ADA Self Evaluation and Transition Plan

MiraCosta College
Technology Center Institute, Carlsbad, CA
05-08-2017

Client: Steinberg, Joe Sion
 Prepared by: Izor and Associates, Inc.; Greg Izor, CASp-014
 Site Name & Location: MiraCosta College, Technology Center Institute, 2075 Las Palmas Dr., Carlsbad, CA
 Scope of Review: Parking and Exterior Path of Travel, Interior Spaces and Interior Common and Staff Areas
 Dates of Site Review: 10-14-2016
 Dates of Draft Report: 10-14-2016
 Date of Final Report: 05-08-2017 CASp Determination: Inspected by a CASp
 File Name: 170508 TCI CASp Report-Final
 Adopted by MiraCosta College Board of Trustees on: TBD

G. Site Diagram

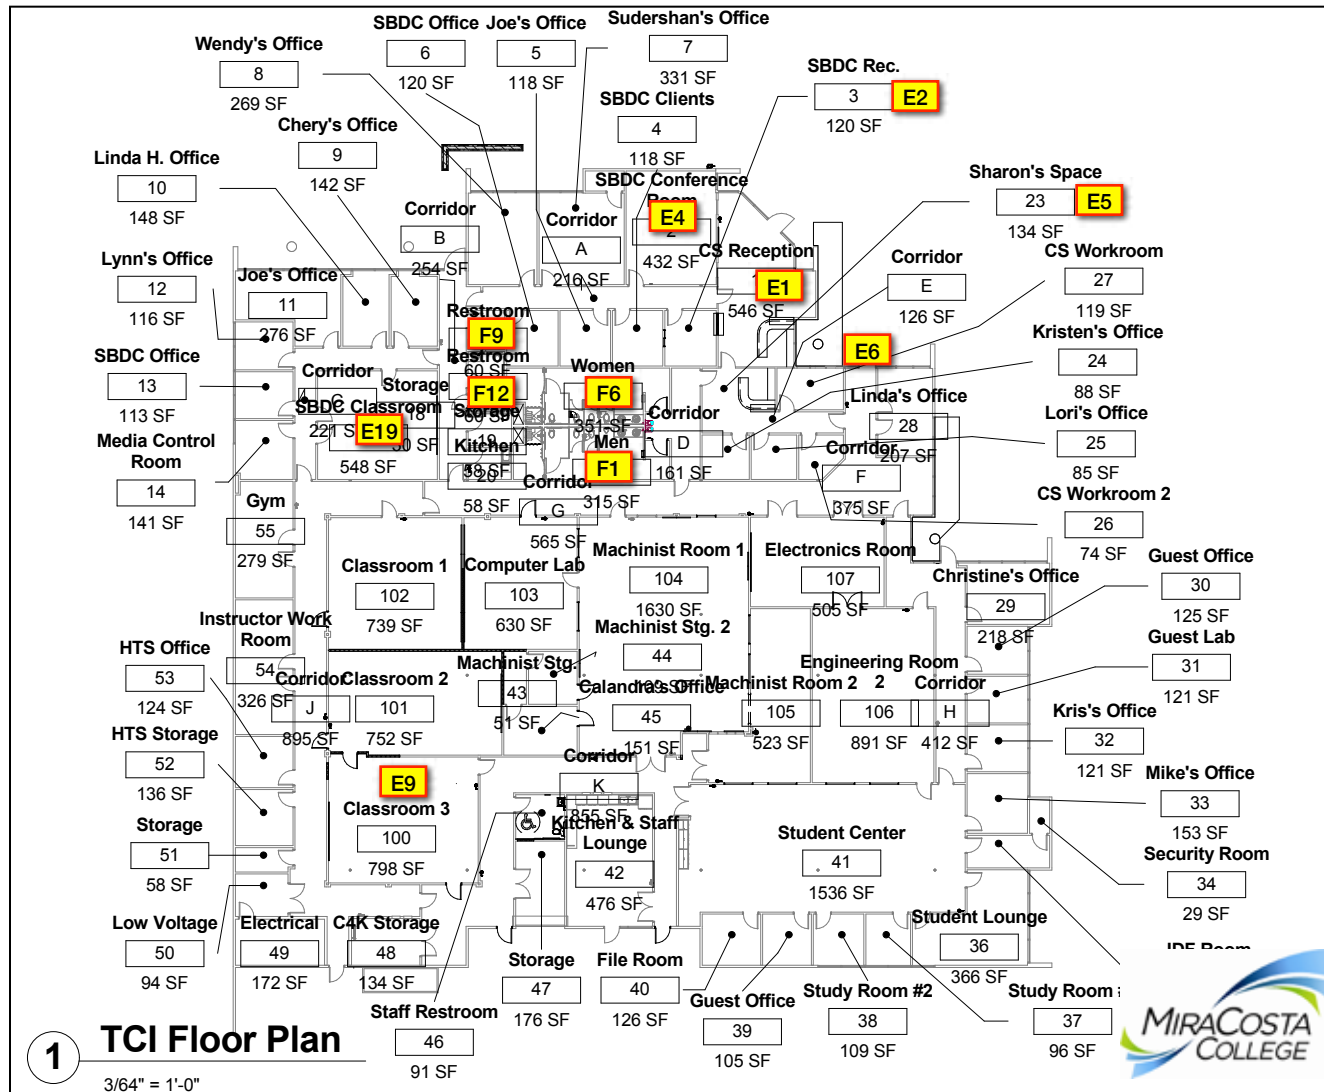
#	ITEM	PHOTO or DIAGRAM	MITIGATION MEASURE	Phase
C. Onsite Path of Travel				
C1	These stairs are compliant		None required	N/A
C2	The POT leading from the parking to the wheelchair accessible ramp is compliant		None required	N/A
C3	The ramp is not compliant. The required width of 48" is not provided. (44")	 	1. Reconstruct the ramp and handrails according to appendix C.2, C.3 and C.7 to provide 48" minimum width.	P2

#	ITEM	PHOTO or DIAGRAM	MITIGATION MEASURE	Phase
C6	This POT is not compliant There is no curb ramp leading from the emergency exit.		Install a curb cut curb ramp according to appendix A.4 - A.6	P2
C7	The employee break area is not compliant. The table serving the area is not wheelchair accessible		Install a table that has a wheelchair accessible seating knee clearance space according to Appendix B.1	P2
